June 14, 2021

## **Addendum No. 1:**

### **Project: PSFA PROJECT NO: P19-009 – Mesa Middle School Renovations and Addition – Roswell Independent School District and PSFA**

**B2 PHASING PLAN - PHASE 2 NEW CONSTRUCTION / RENOVATIONS**  
NTS

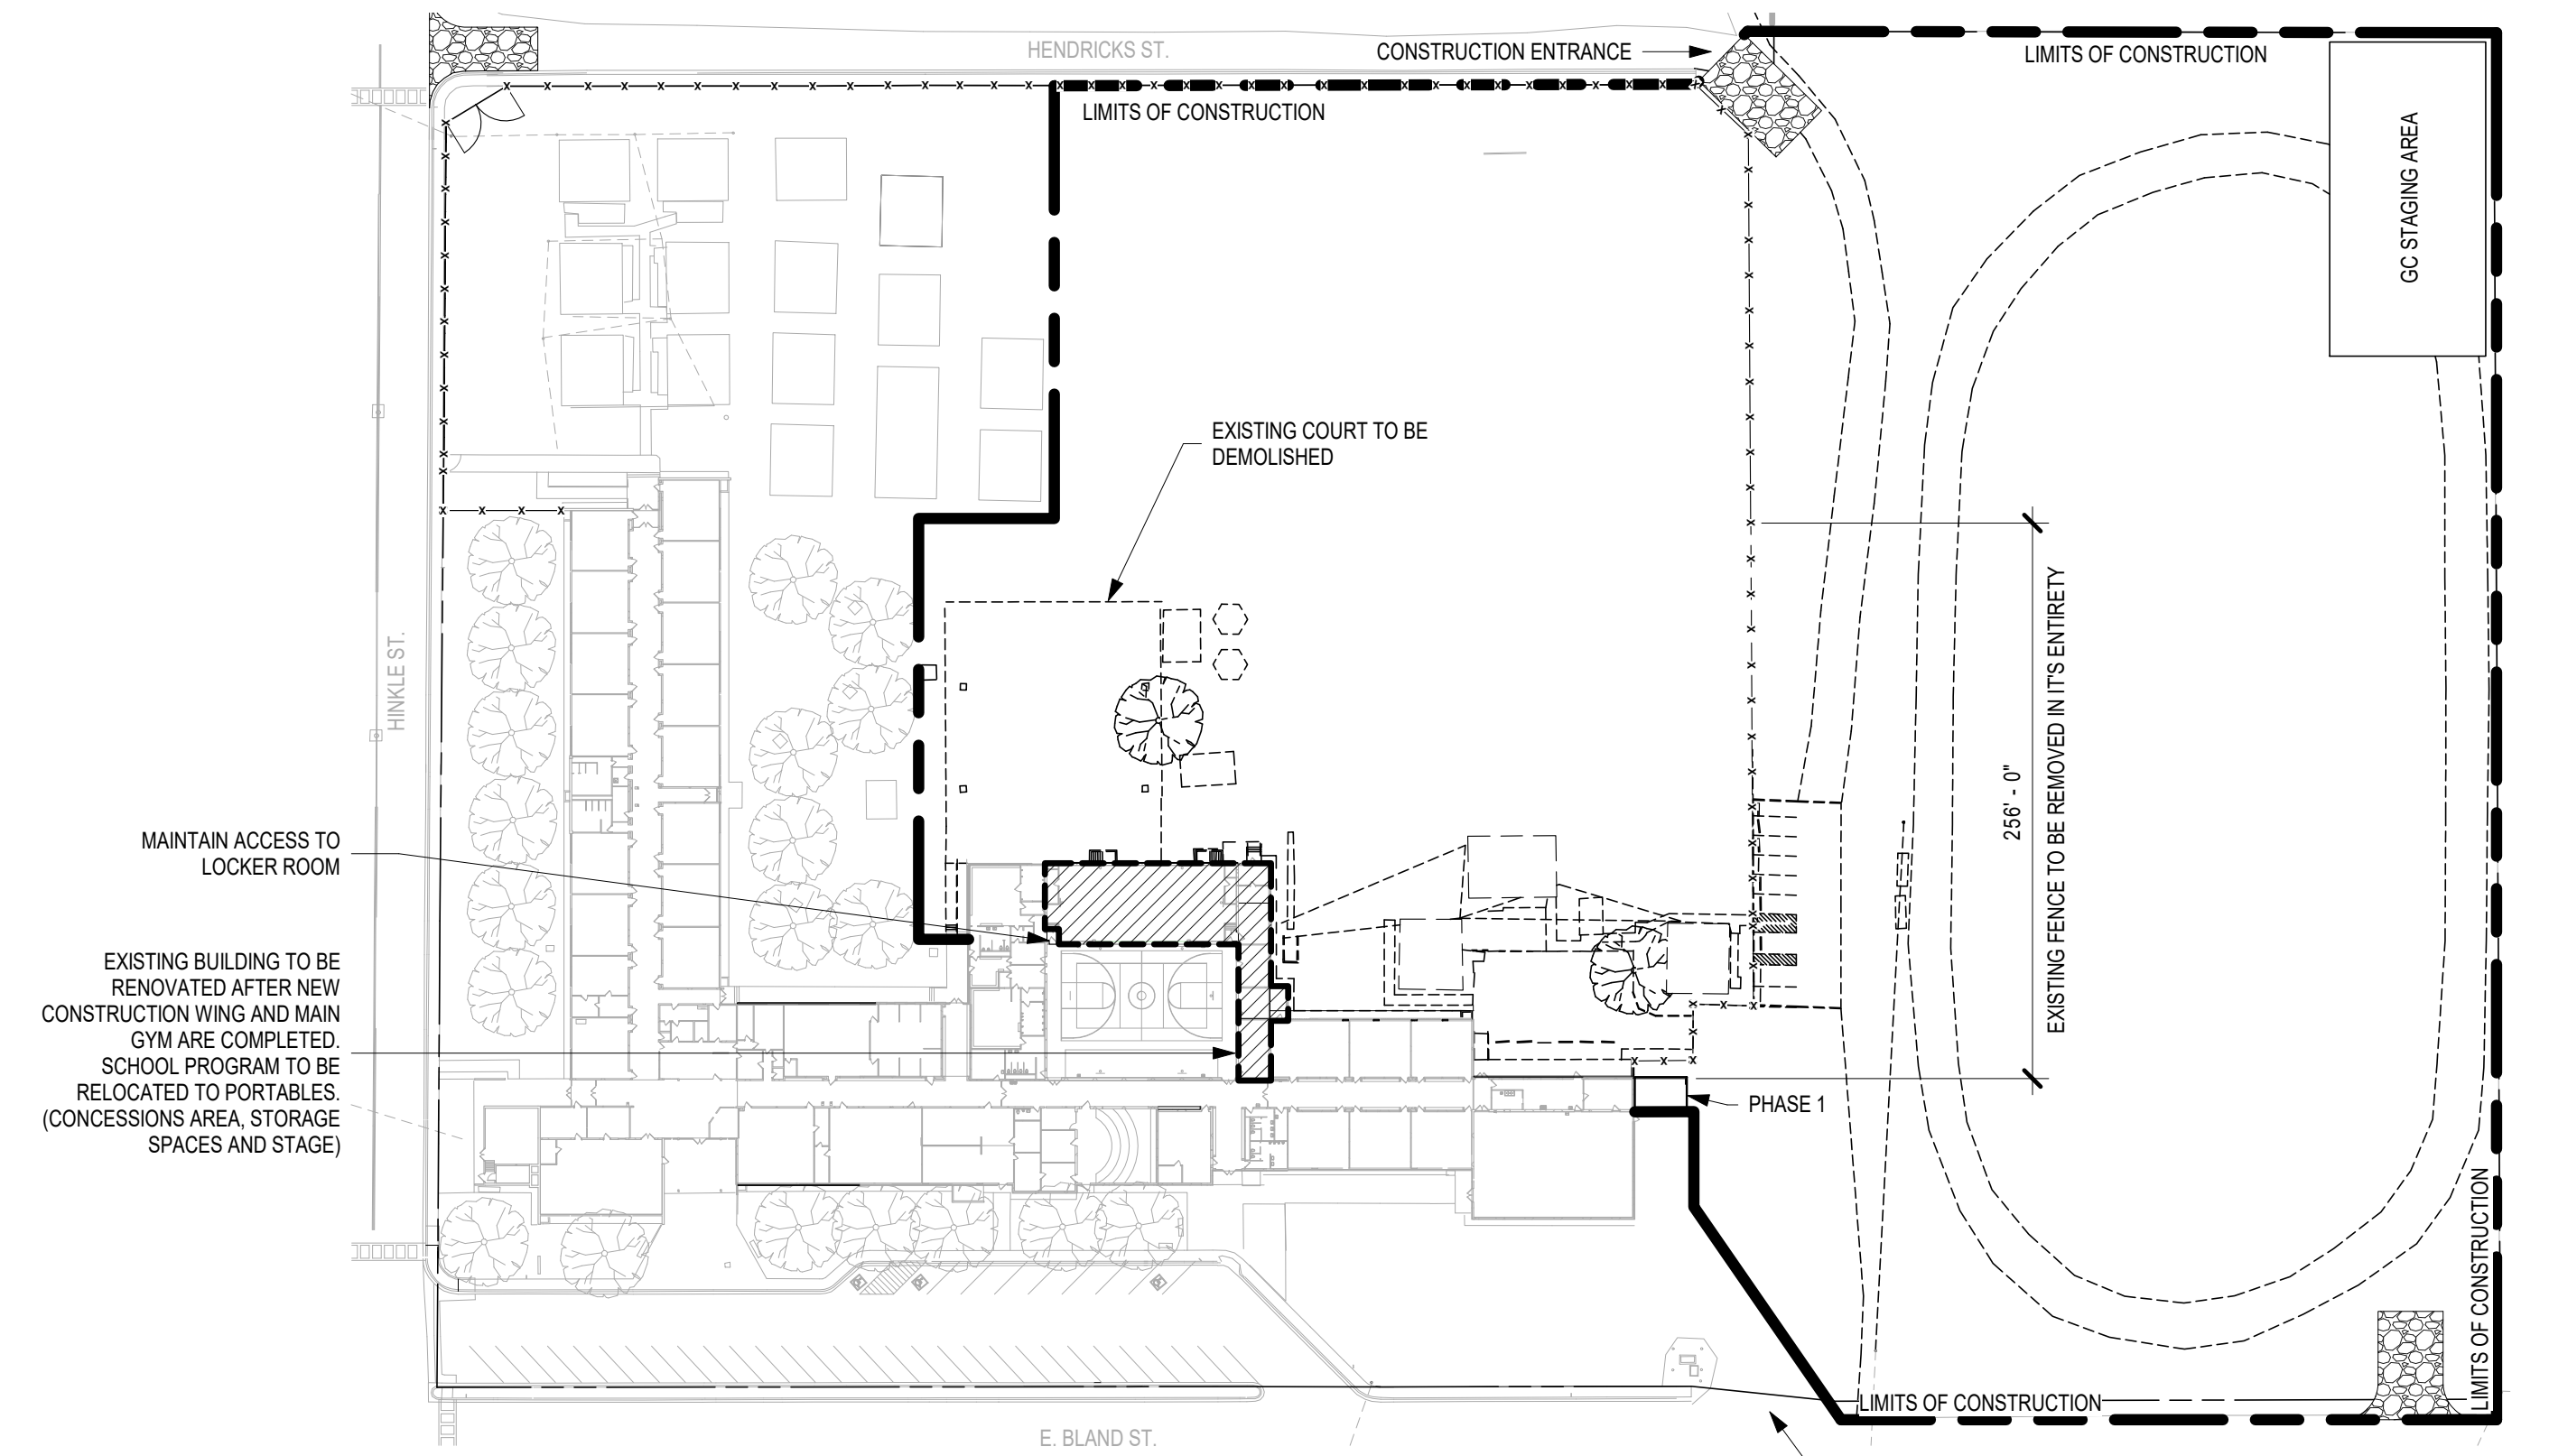
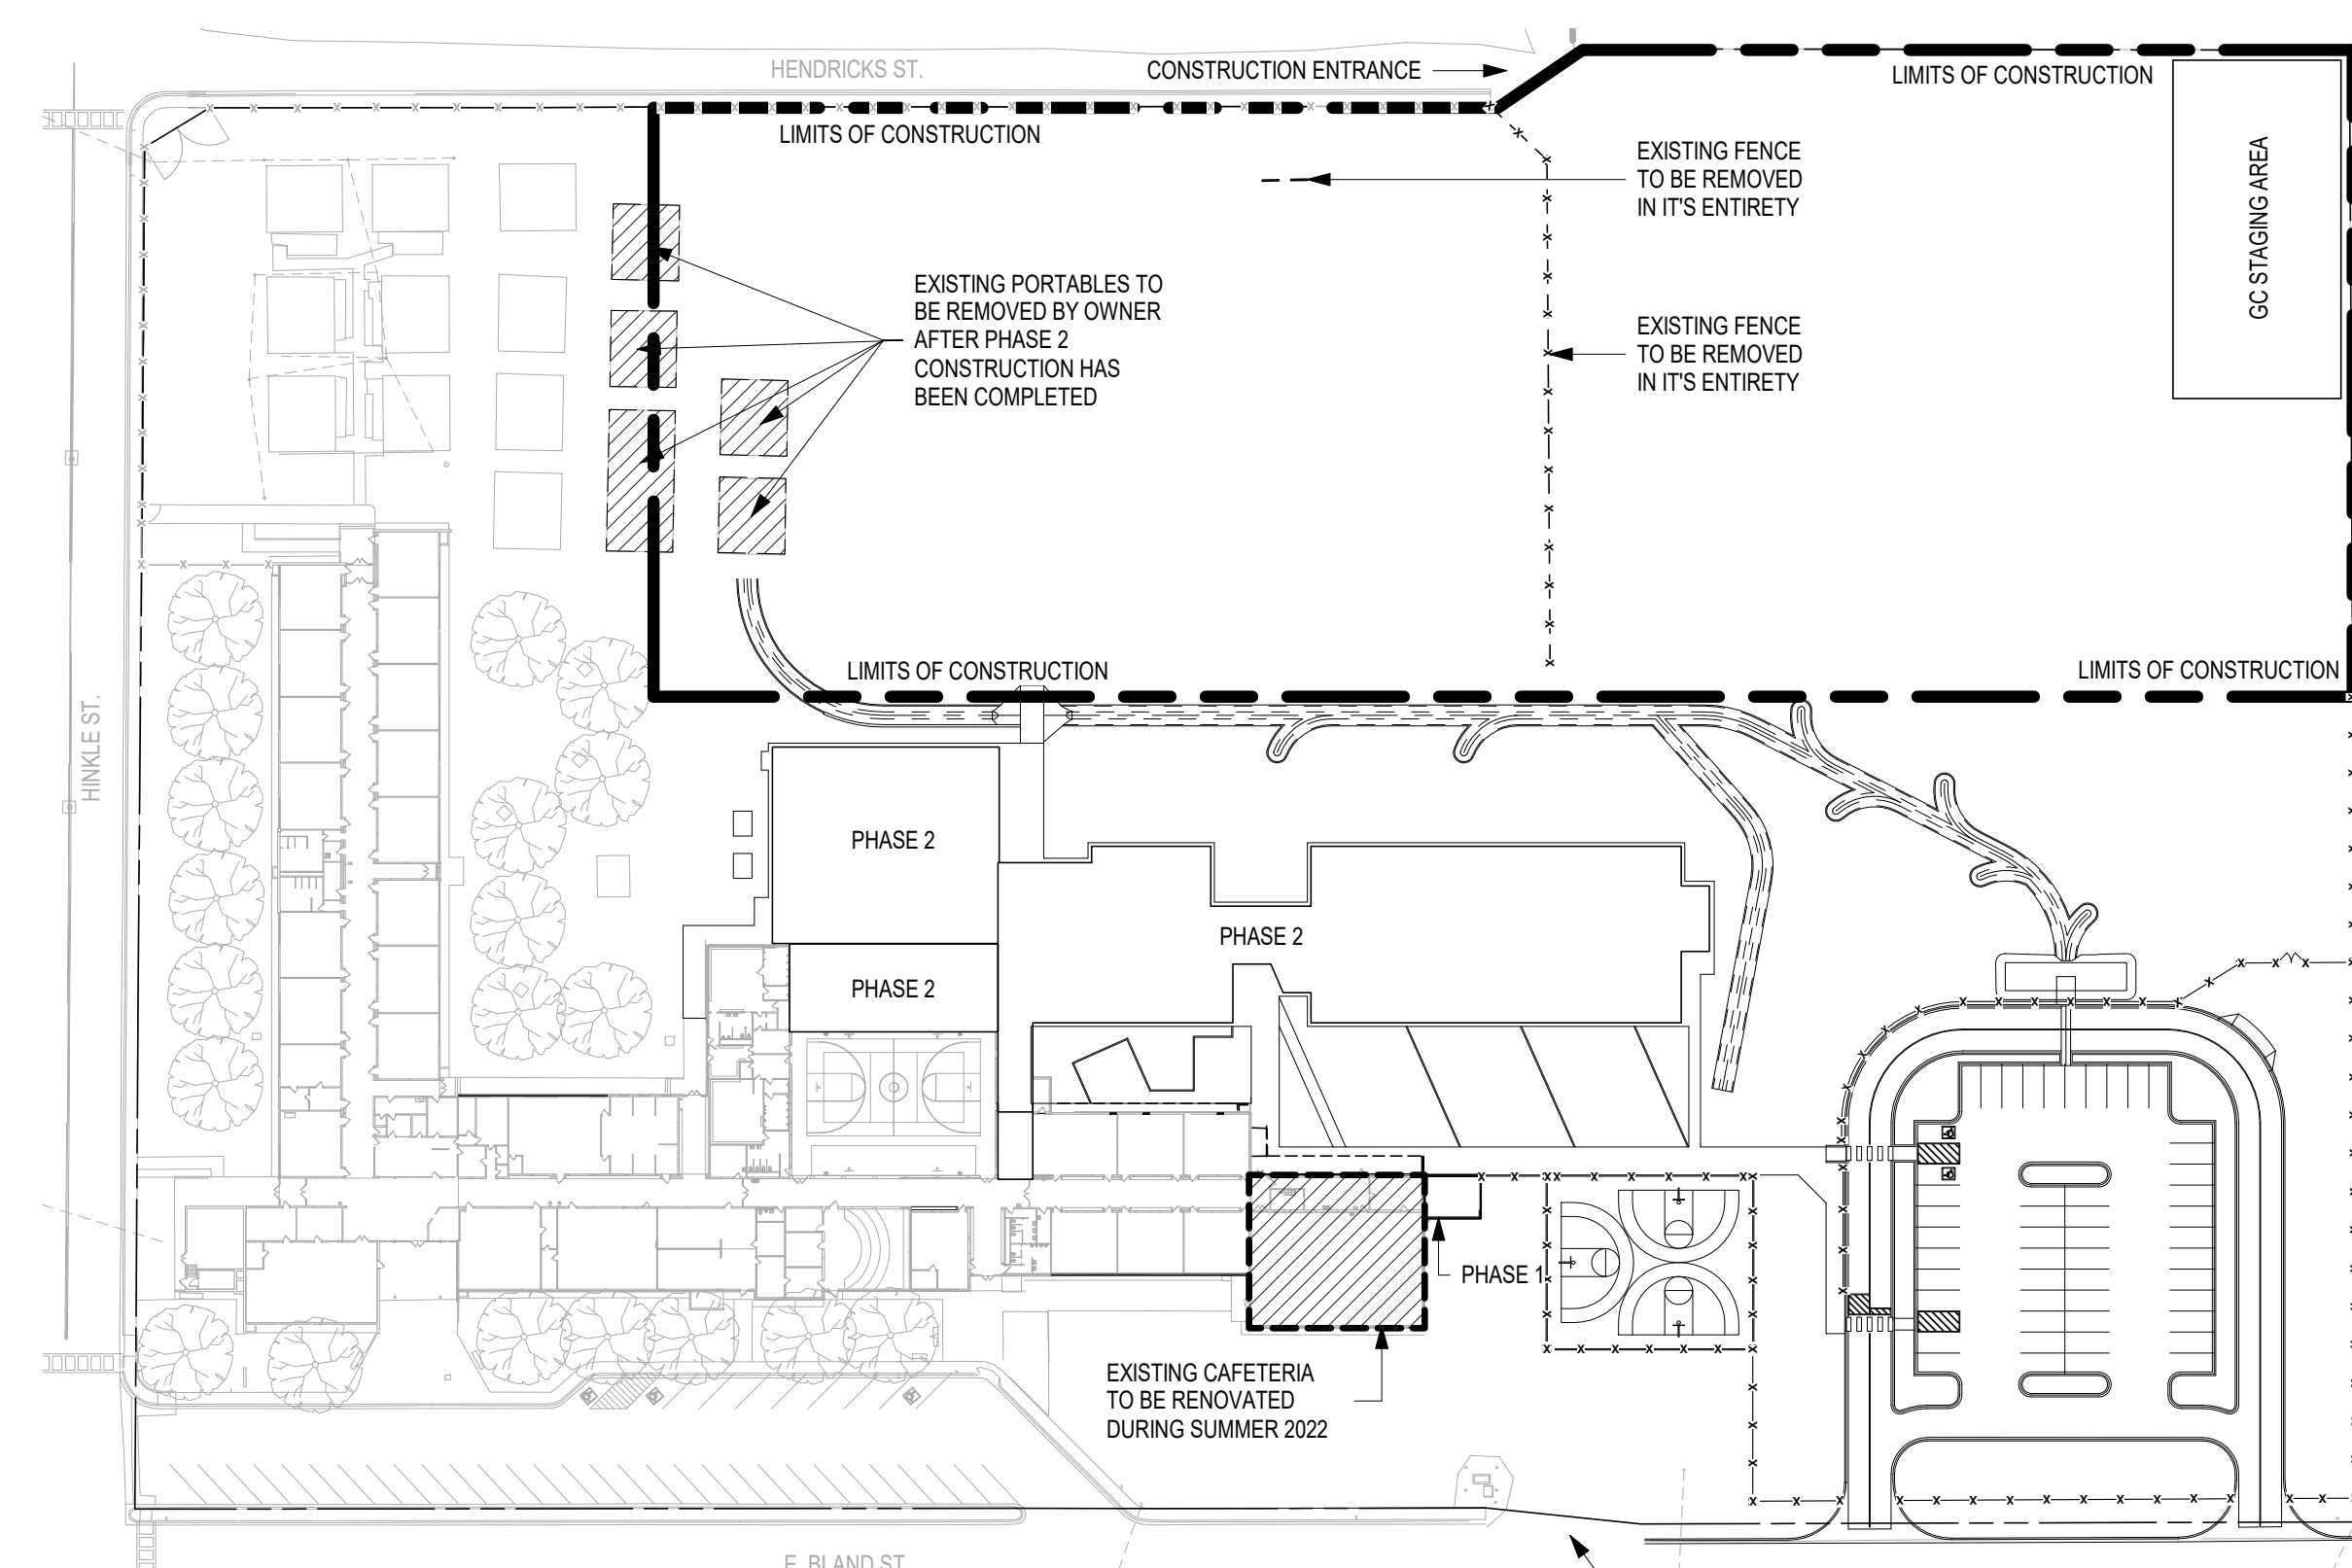
10. *G-005 specifies "Existing Cafeteria to be renovated during summer." Keeping in mind the anticipated award date of July 14, what is the deadline for completion of this portion of work?*

17. *Phasing Plan B2 "Phase 2 Demolition" indicates "corridor to remain accessible to students." Will this corridor need to remain open throughout construction?*
  - a. **Yes, path to cafeteria to remain open during construction.**
18. *How long will it take to relocate the school program to portables before Phase 2A commences?*
  - a. **No Phase 2A shown on Sheet G-005. Clarify question.**

- a. **See updated G-005 and G-005A Phasing Plans in this Addendum.**
11. *Is the General Contractor responsible for the abatement of existing facilities?*
